PROJECT : HONOAPIILANI HIGHWAY
Kahana to Alaeloa

PROJECT NO.: F-030-1(13)

DRAINAGE

STATE OF HAWAII
DEPARTMENT OF TRANSPORTATION
LAND TRANSPORTATION FACILITIES DIVISION
DRAINAGE & IRRIGATION PLAN
HONOAPIILANI HIGHWAY
Kahana to Aiealoa
F.A. Proj. No. F-030-1(13)

SHEET NO. 01 OF 8 SHEETS

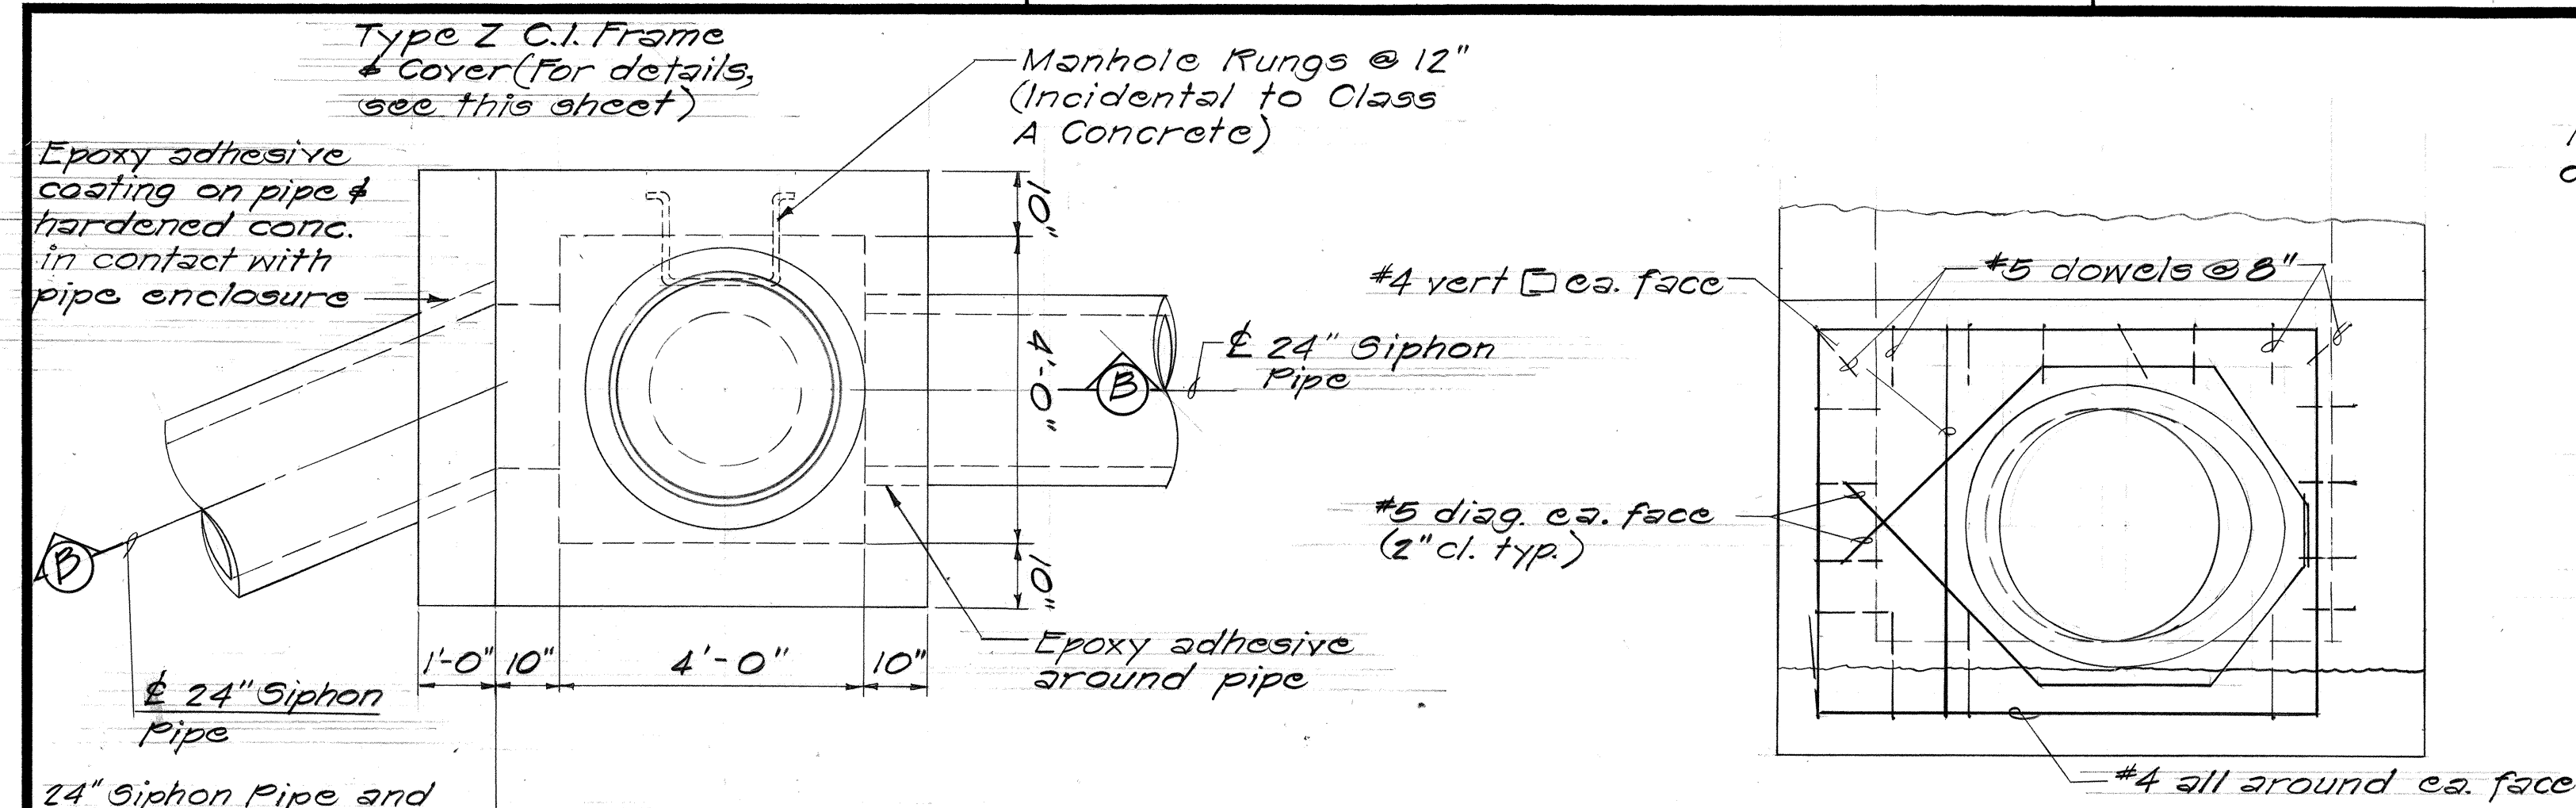
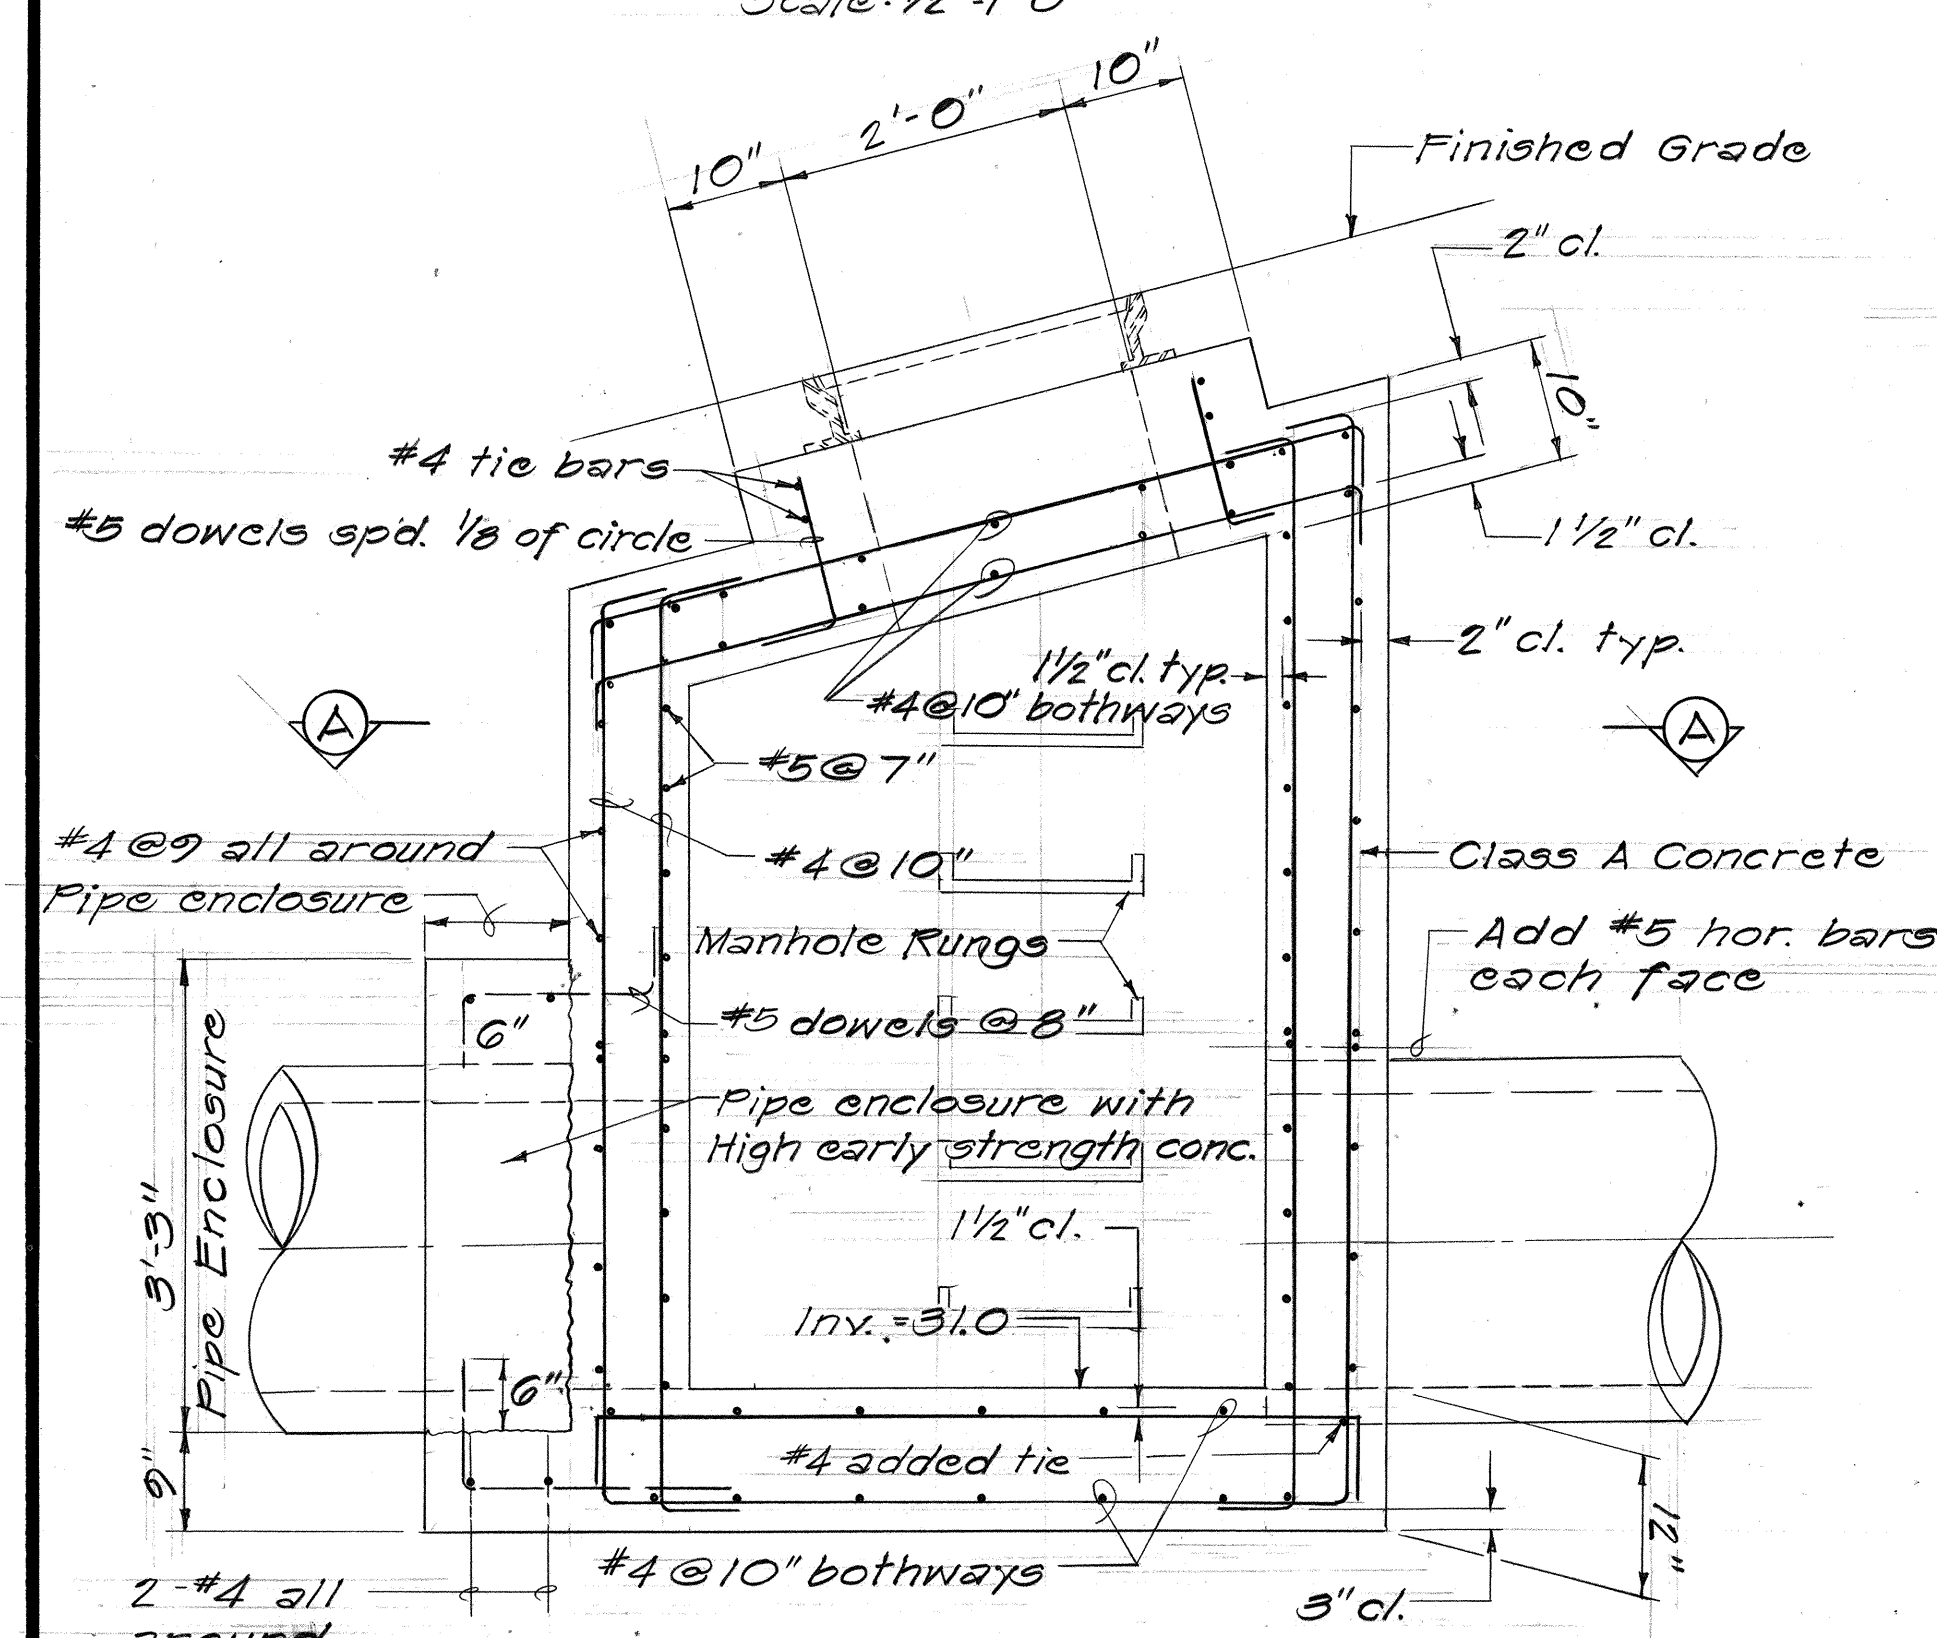
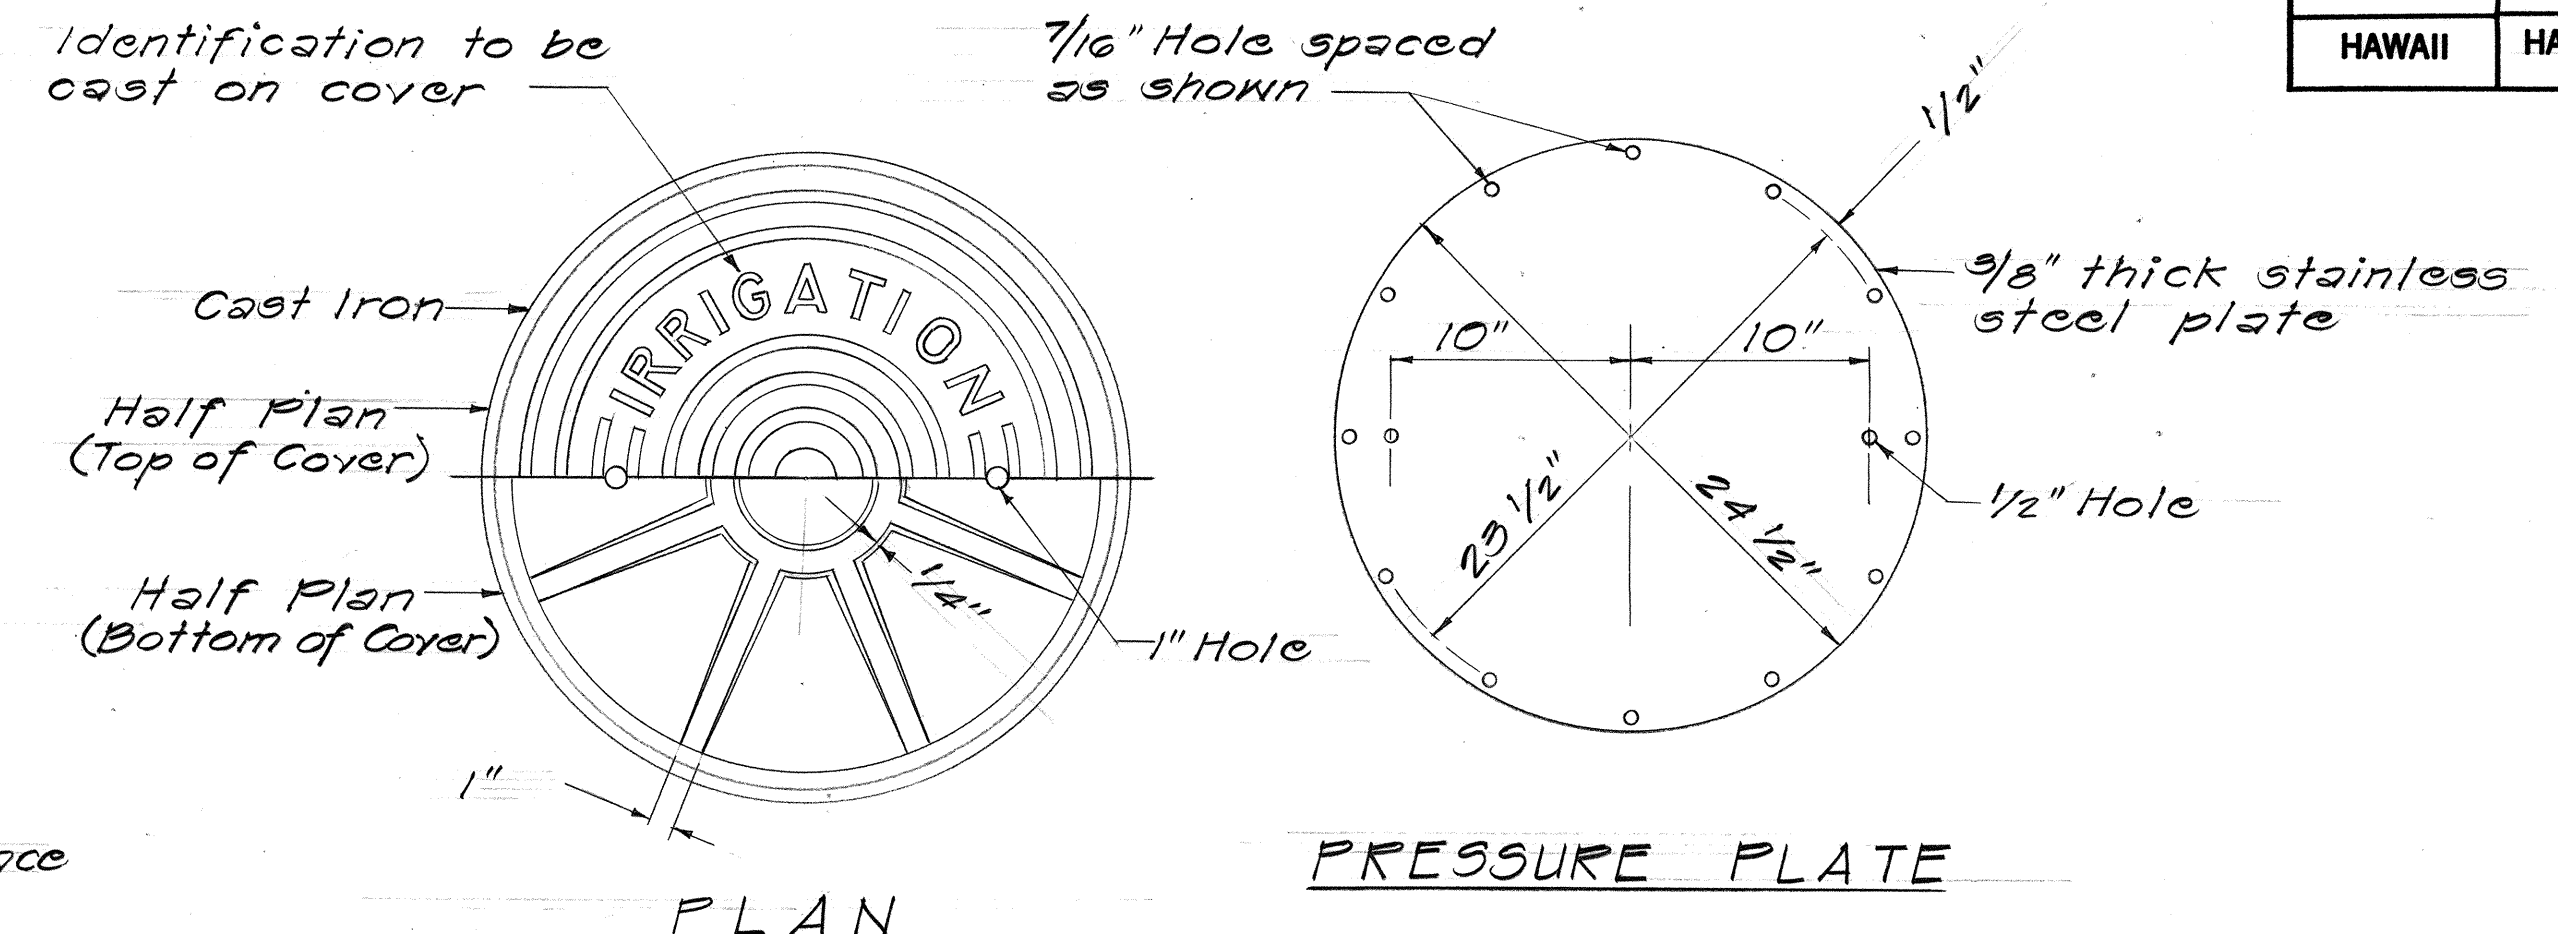
13 Nov 79 Tracing deleted from contract plan due to relocation of irrigation crossing to Sta 128+05
